SUNDRY NOTICES AND REPORTS ON WELLS
Do not use this form for proposals to drill or to re-enter an abandoned well. Use form 3160-3 (APD) for such proposals.

8. Well Name and No.
GALLEGOS CANYON UNIT 22

Gallegos Canyon Unit # 22
API No. 30-045-07479
Plug & Abandonment Procedure
August 9, 2004

Gallegos Canyon Unit 22

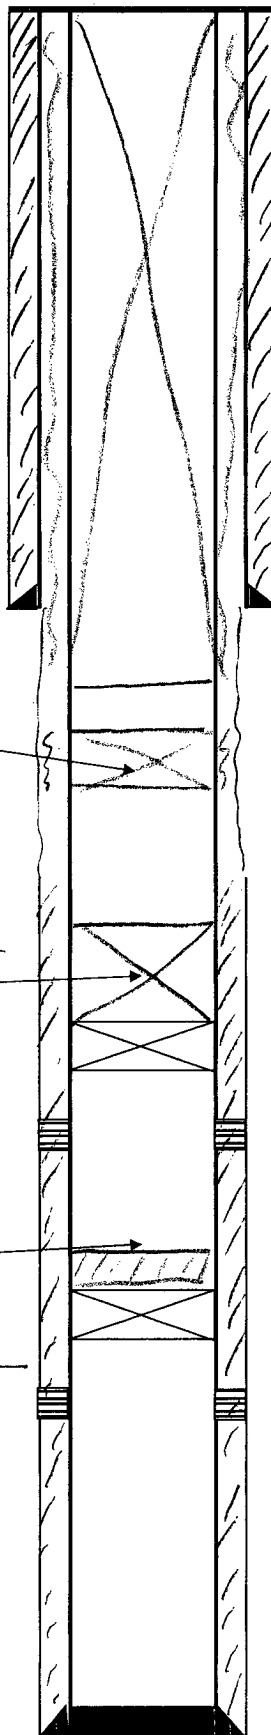
plug 248 - surface

$$248 / 4.399 (1.18) = 48 \text{ sxs}$$

$$243 / 6.652 (1.18) = 18 \text{ sxs}$$

$$105 / 3.341 (1.18) = 27 \text{ sxs}$$

93 sxs

$$150 / 4.399 (1.18) = 29 \text{ sxs}$$

$$200 / 6.652 (1.18) = 25 \text{ sxs}$$

7" Csg. TOC @ 970'

plug 1296' - 1058'

$$(1296 - 1058 + 50) / 4.399 (1.18) = 59 \text{ sxs C.I.B.}$$
